Value Engineering Study Report
– Final

I-69 Ohio River Crossing Project
Evansville, IN and Henderson, KY

August 2, 2019

Idea Title	Optimize interchanges in terms of connectivity and priority of access (US 60)
Function	Access Community

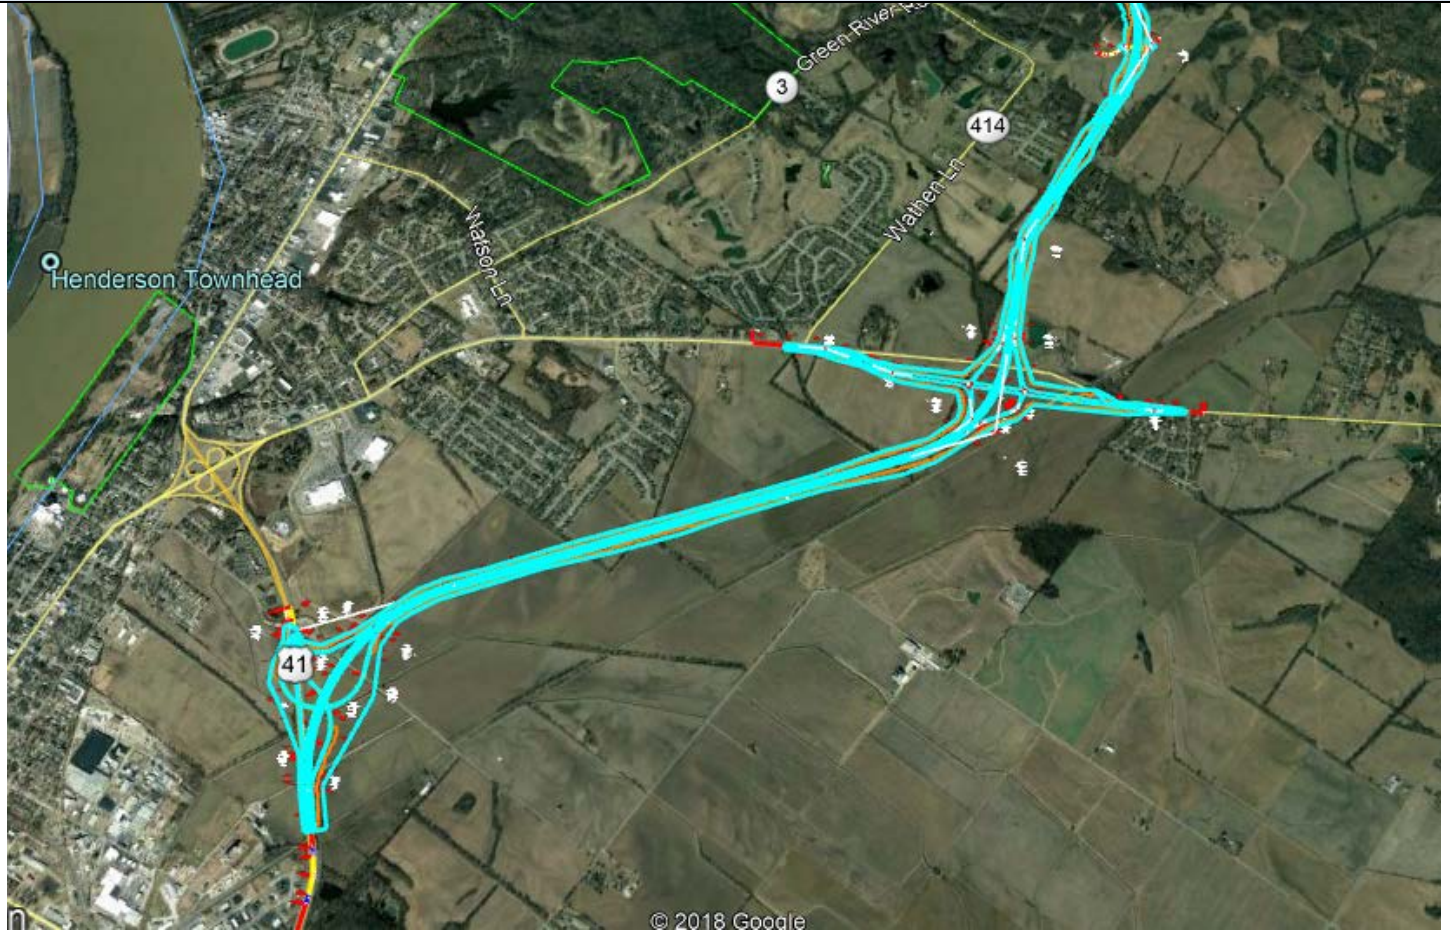
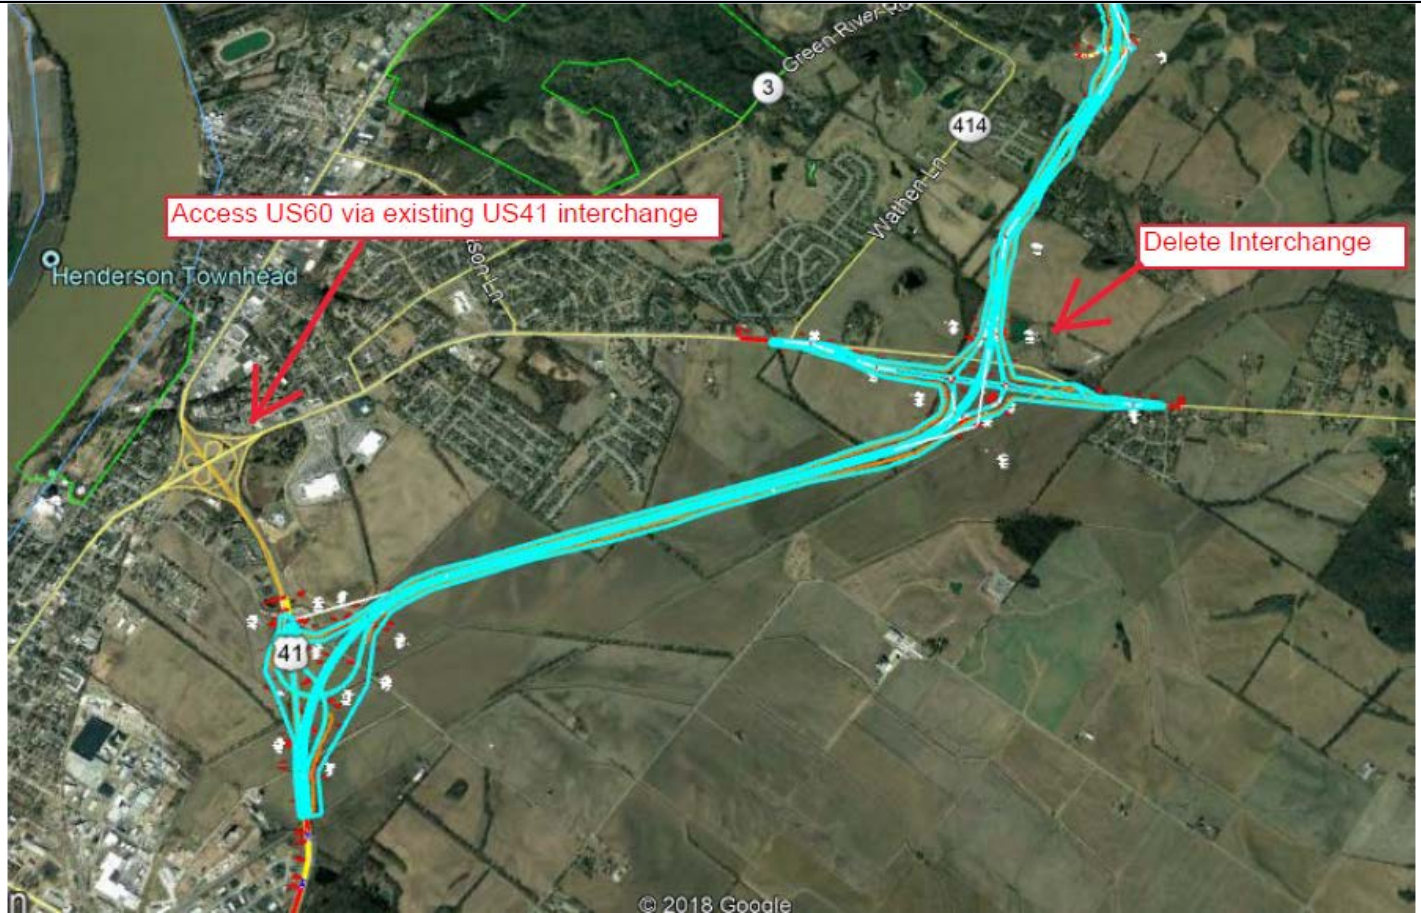
COST IMPACT:	<u>Rough order of magnitude impact to cost (potential cost avoidance) - \$5M</u> Reduce cost by roughly the same number as for SR-06, Remove US 60 interchange.
SCHEDULE IMPACT:	<u>Rough order of magnitude impact to schedule (reduce schedule) – 3 months</u> Same schedule savings as SR-06, Remove US 60 interchange.

- Redefining the preferred alternative, communicating that change to the public, and documenting it in the FEIS.
- Conducting additional traffic analysis to identify changes in traffic volumes and potential implications for revenue, and what portion of volumes projected to access I-69 at the new interchange would find/use alternative path to get on I-69 at the I-69/US 41 interchange.
- Including design and right of way elements to not preclude implementation of the interchange later on.

Idea Title	Collapse/combine US 41/US 60 interchanges
Function	Access Community

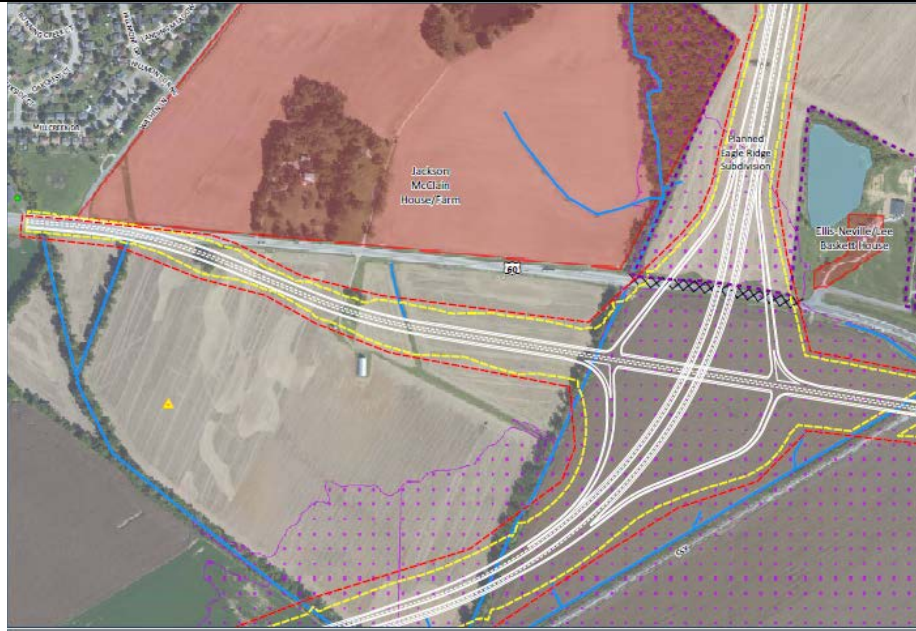
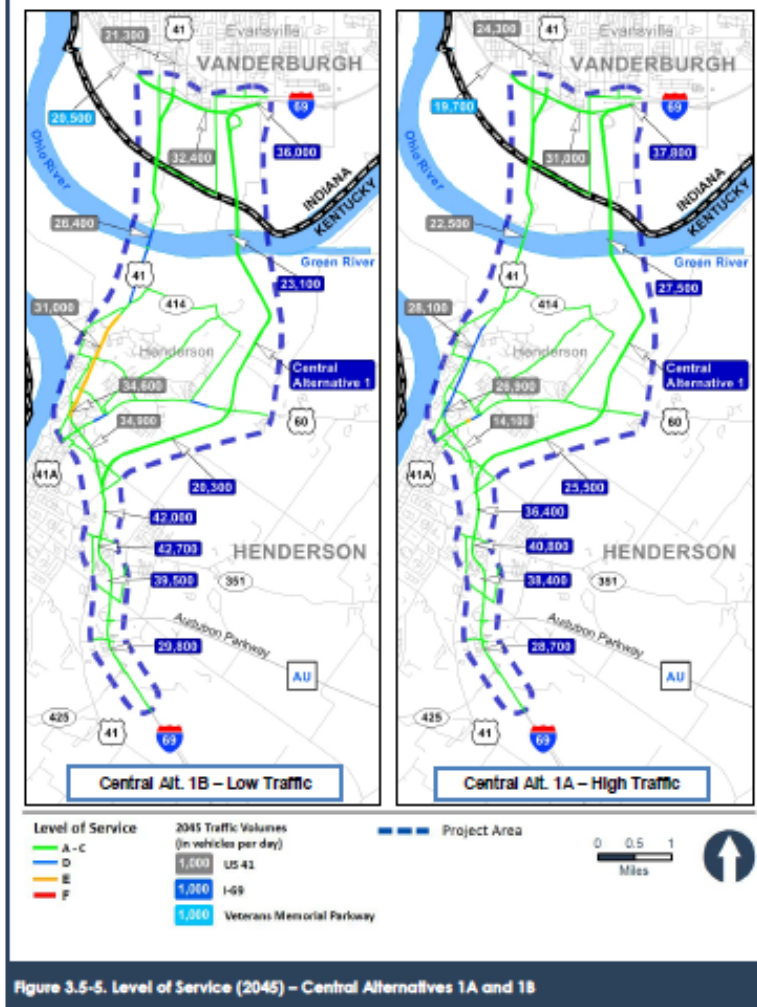
Currently, there are two new interchanges proposed for the *Central Alternatives 1A and 1B I-69 Alignment (Preferred Alternative)*—one at US 60 and one at US 41. Both the US 60 and US 41 interchanges provide full access for all movements to/from I-69.

The Alternative Concept proposes to either “collapse and/or combine” the US 60 and US 41 interchanges currently proposed under the Preferred Alternative into either one interchange or possibly into two partial interchanges. This reduces cost through the elimination of non-critical movements, and therefore access ramps and potential structure modifications, based on traffic demand needs and an aim to reduce redundant movements in proximity to one another. Since the proposed US 60 interchange is currently classified as a “service interchange” and the US 41 is classified as a “system interchange” it would be more practical to eliminate the US 60 interchange (refer to proposal SR-06, Remove US 60 interchange) or reduce access and provide main access to US 60 via US 41 to be confirmed via O/D analysis.

Based on a refinement of the traffic analysis (origin/destination survey), it is proposed that the interchanges of US 60 and US 41 with the proposed alignment of I-69 be reviewed to determine which movements should be accommodated as critical movements and which movements should be eliminated or provided for in the future (where practical). This reconfiguration would provide a cost savings to the currently proposed baseline project (Central Alternatives 1A and 1B I-69 Alignment). As current traffic data is not available at this time, the approach of this concept is to point out the potential “cost targets” that make up the estimated construction cost of the various ramps and structures that could be either eliminated or reconfigured – approximately \$21M. The total cost savings would depend on the elimination/reconfiguration of ramps and the reduction of structural costs based on the interchange refinements.

1. Elimination of US 60 interchange; keep the proposed US 41 interchange as proposed.
2. Elimination of US 60 interchange; reconfigure ramps at US 41 to provide free flow high volume movements to I-69; reconfigure ramps to US 41 (and other connections) to minimize cost.
3. Reconfigure both US 60 and US 41 interchange ramps to provide necessary access based on O/D analysis (potential for partial interchanges at both locations) related to critical movements.

Idea Title	Relocate Parcel 627 access
Function	Access Community

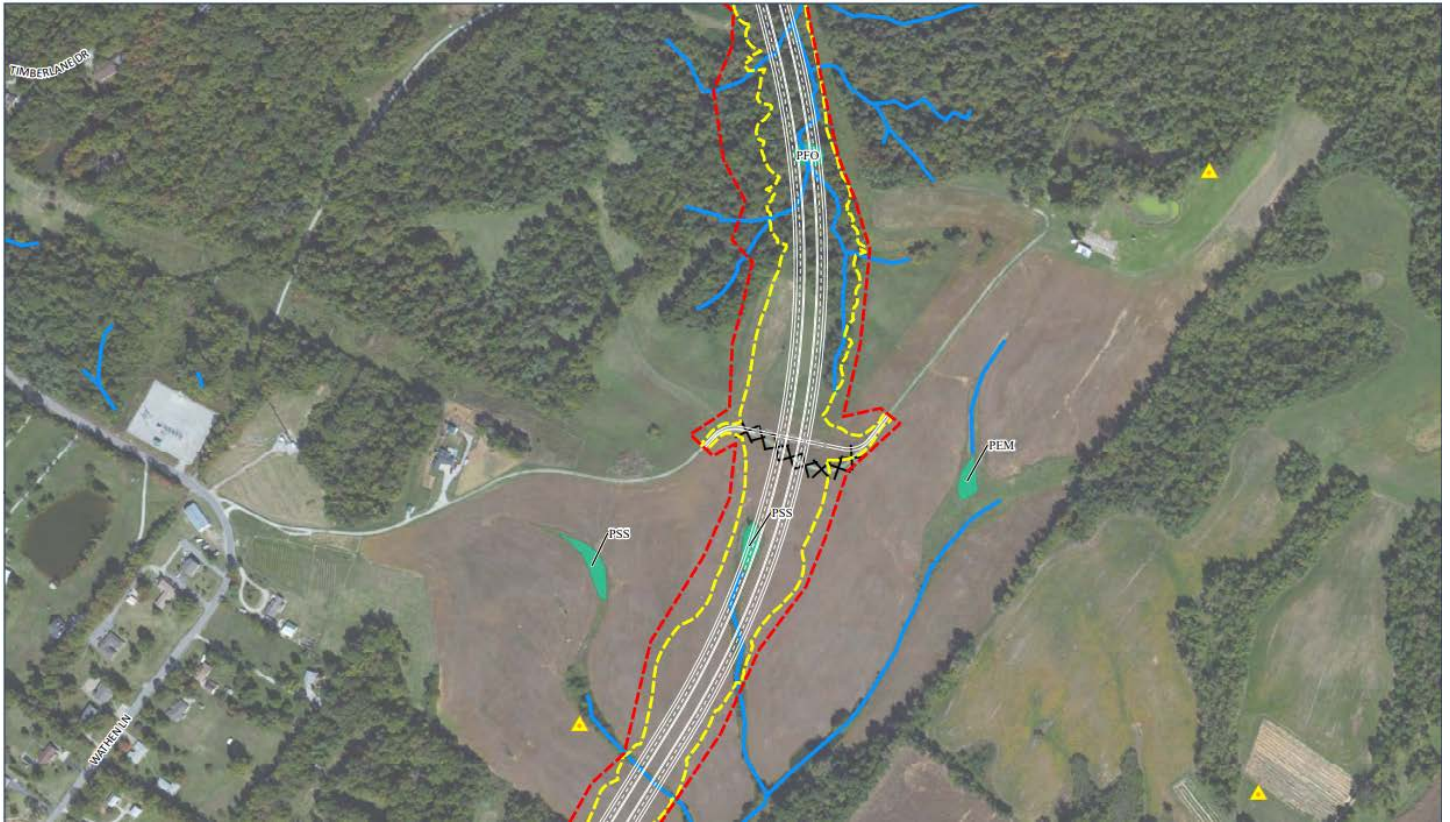
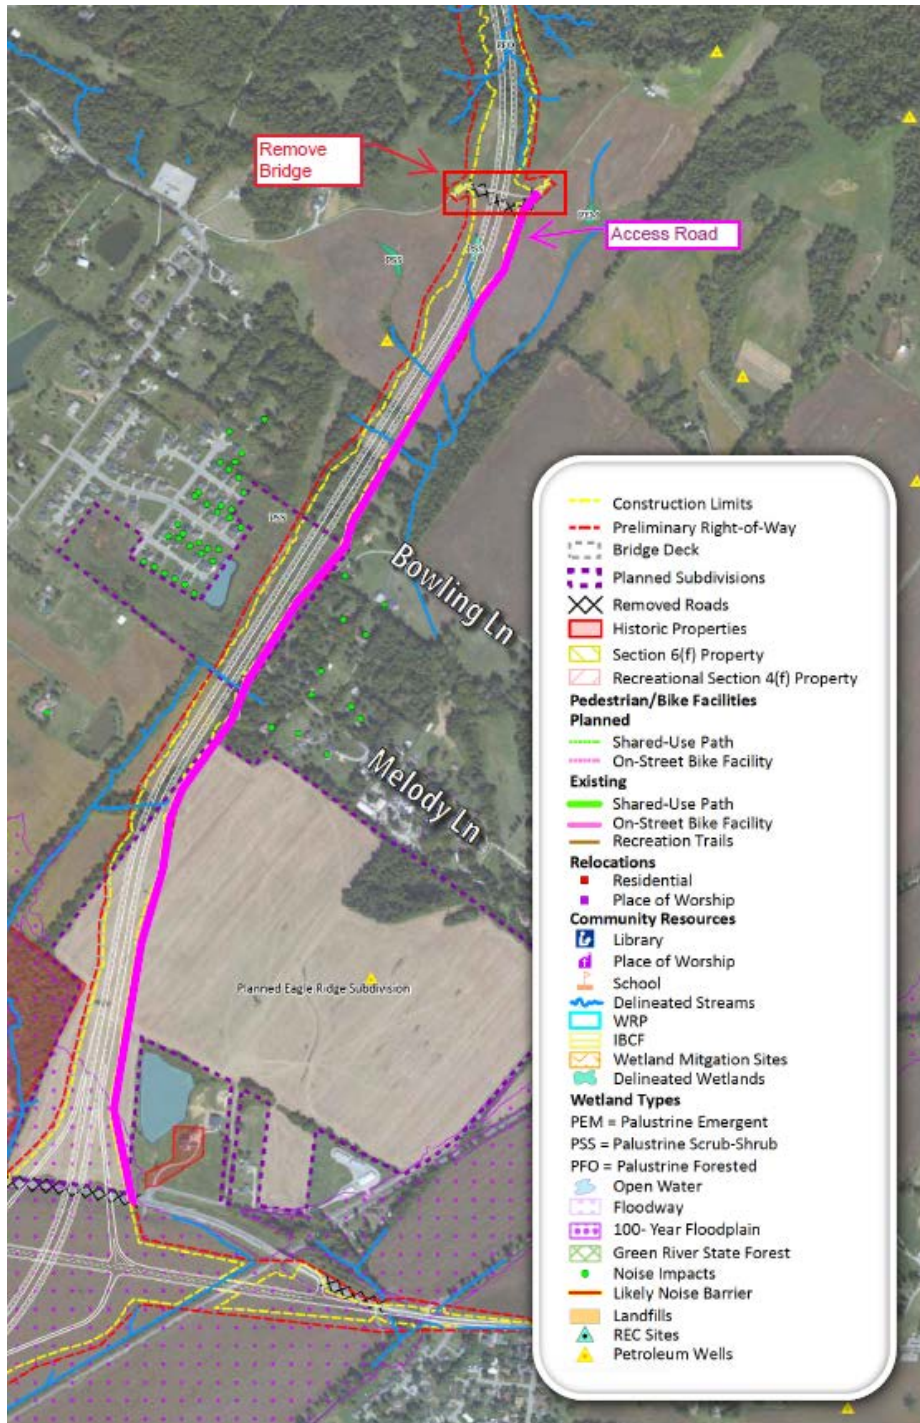
SCHEDULE IMPACT:	<u>Rough order of magnitude impact to schedule (add/reduce schedule) – 3 months</u> Eliminating the bridge and being able to construct the gravel road at the same time as the I-69 corridor
-------------------------	--

\$1,660,000 - \$600,000 = \$1,060,000

Idea Title	Simplify/minimize I-69 interchange at Veterans Memorial Parkway
Function	Access Community

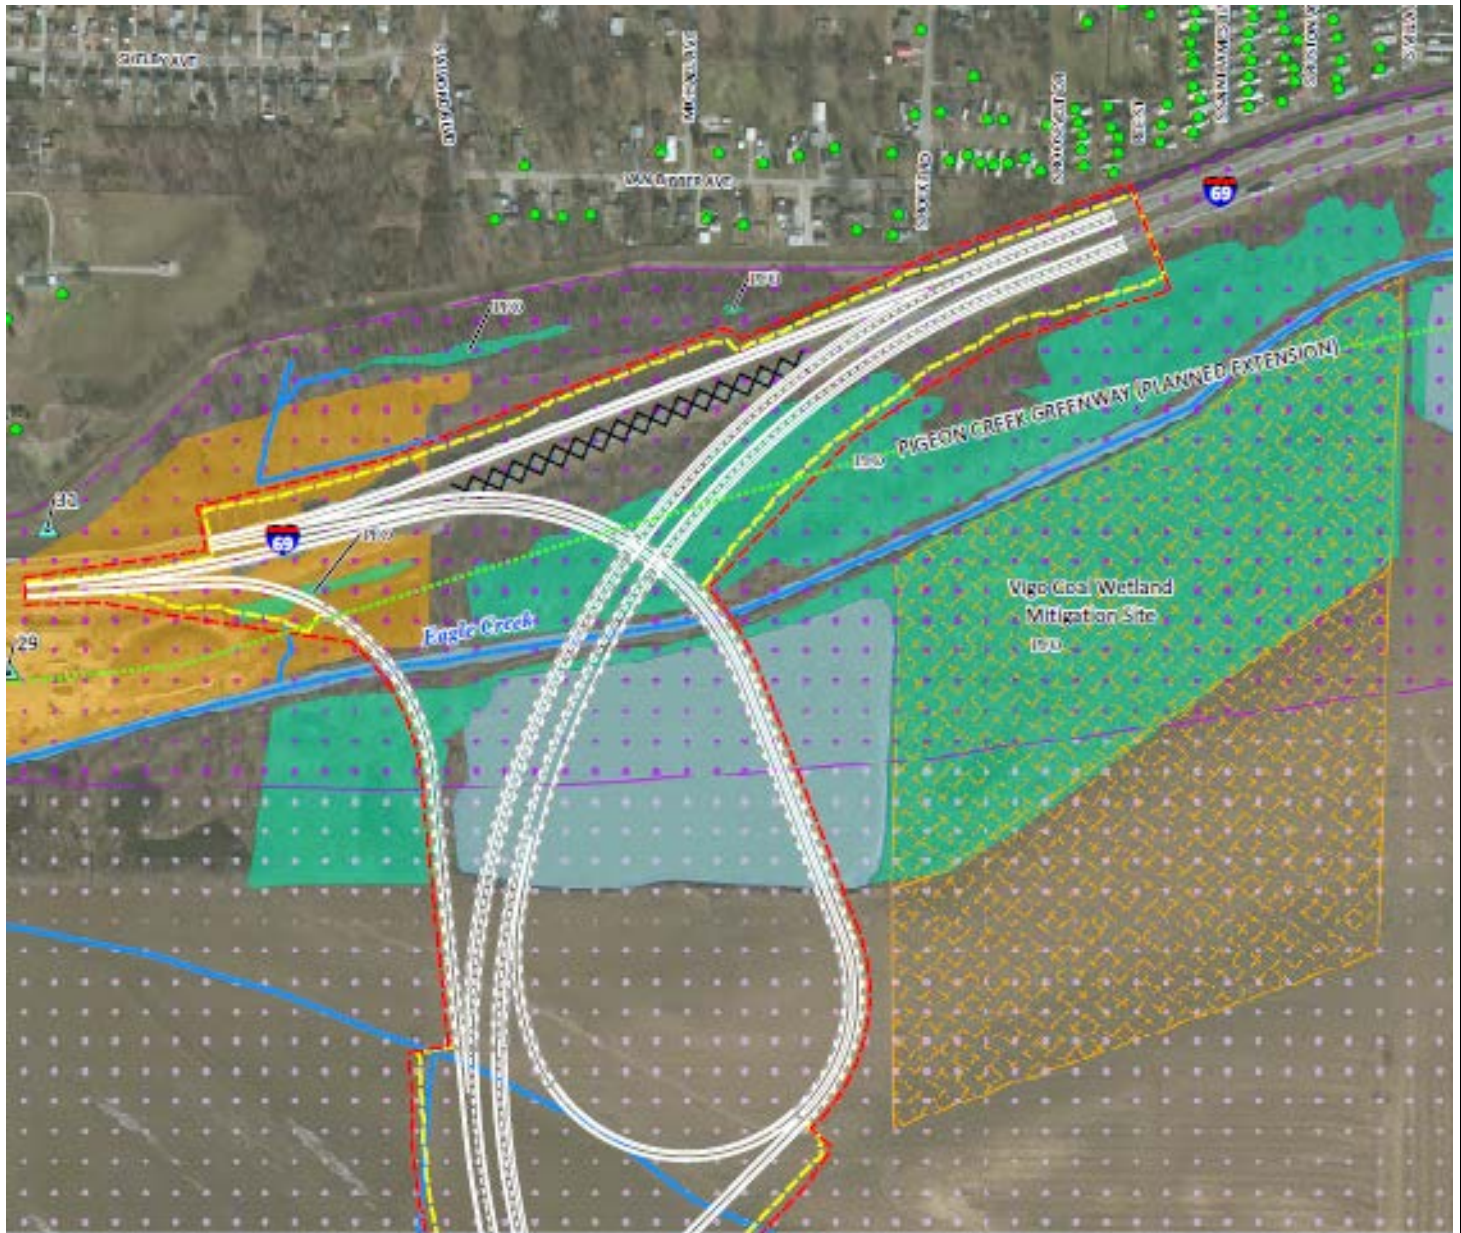
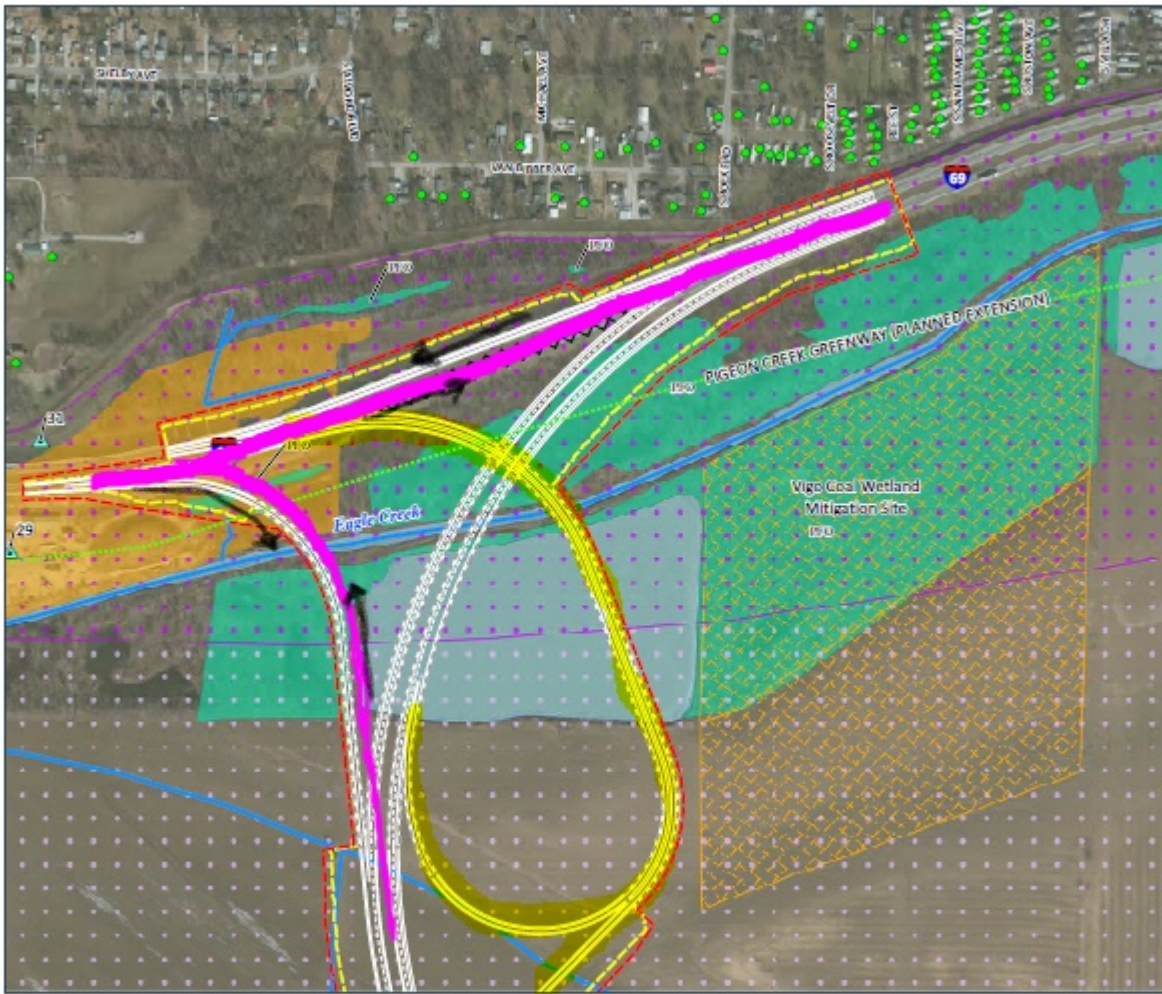
1. No change to eastbound VMP to southbound I-69 ramp movement.
2. Construct northbound I-69 at a higher elevation (17 feet) than southbound I-69. This allows a northbound I-69 left off ramp (fast lane exit) to crossover southbound I-69 to tie-in with westbound VMP. Additionally, this same northbound I-69 to westbound VMP will have a left side on-ramp to westbound VMP. This left-off to left-on ramp proposal shortens the bridge length requirement and allows for a great portion of the ramp constructed on fill.

4. No change to southbound I-69 to westbound VMP ramp.

May reduce environmental permit requirements by smaller footprint construction in floodplain.
